HISTORIC AND DESIGN REVIEW COMMISSION

September 04, 2019

HDRC CASE NO: 2019-481
ADDRESS: 204 W CRAIG PLACE
LEGAL DESCRIPTION: NCB 1862 BLK 4 LOT 11 & E 25 FT OF 10
ZONING: R-4, H
CITY COUNCIL DIST.: 1
DISTRICT: Monte Vista Historic District
APPLICANT: SLOCUM WADE
OWNER: SLOCUM WADE
TYPE OF WORK: Window replacement
APPLICATION RECEIVED: August 20, 2019
60-DAY REVIEW: October 19, 2019
CASE MANAGER: Huy Pham

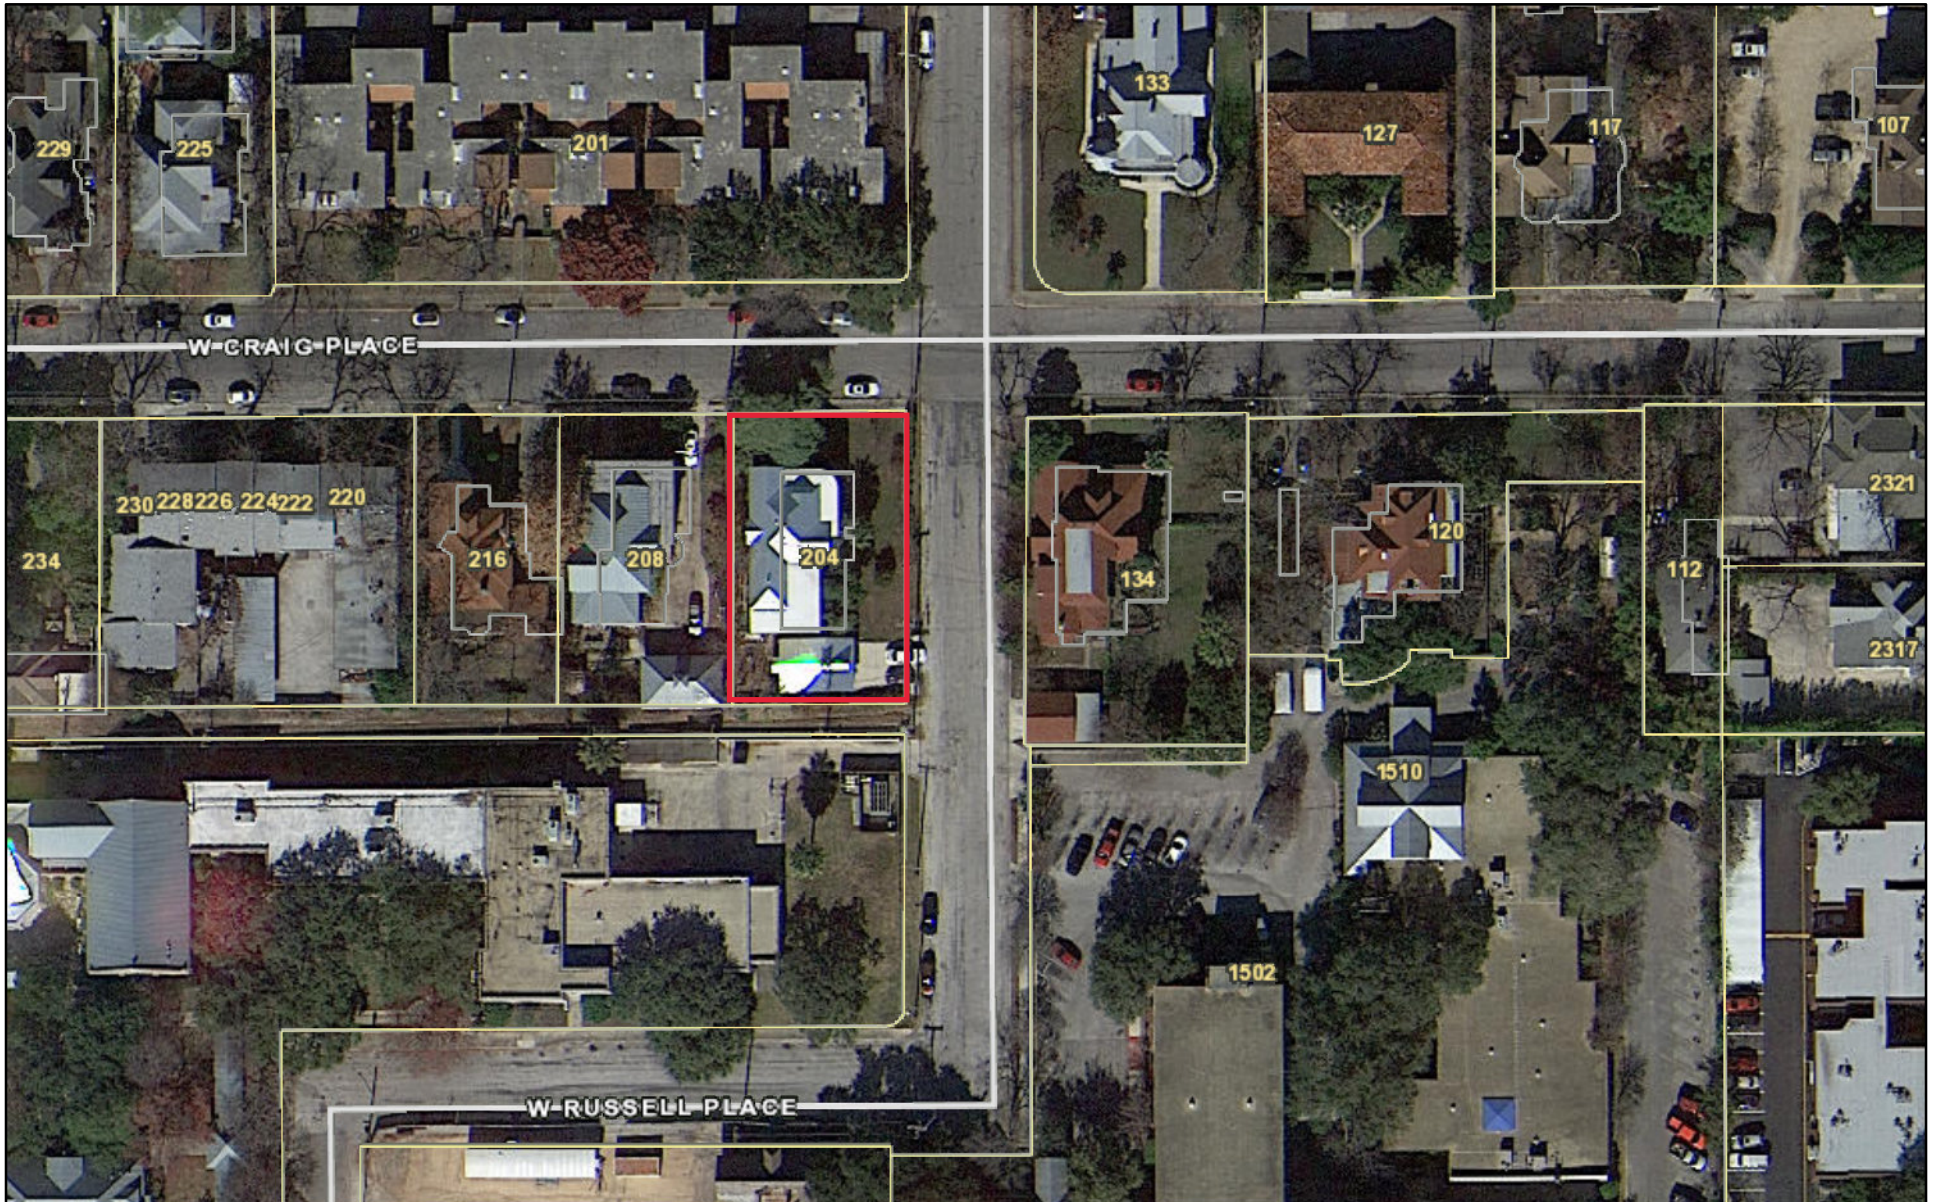
Staff recommends approval based on findings b through e with the stipulations that the replacement wood windows match in all ways to the original wood windows of the house noted in finding e including the standard specifications:

- o SASH: Meeting rails must be no taller than 1.25". Stiles must be no wider than 2.25".
- o DEPTH: There should be a minimum of 2" in depth between the front face of the window trim and the front face of the top window sash. This must be accomplished by recessing the window sufficiently within the opening or with the installation of additional window trim to add thickness.

- o TRIM: Window trim must feature traditional dimensions and architecturally appropriate casing and sloped sill detail. Window track components such as jamb liners must be painted to match the window trim or concealed by a wood window screen set within the opening.

- o GLAZING: Windows should feature clear glass. Low-e or reflective coatings are not recommended for replacements. The glazing should not feature faux divided lights with an interior grille. If approved to match a historic window configuration, the window should feature real exterior muntins.

- o COLOR: Wood windows should feature a painted finished. If a clad product is approved, white or metallic manufacturer's color is not allowed, and color selection must be presented to staff.

- o INSTALLATION: Wood windows should be supplied in a block frame and exclude nailing fins. Window opening sizes should not be altered to accommodate stock sizes prior to approval.
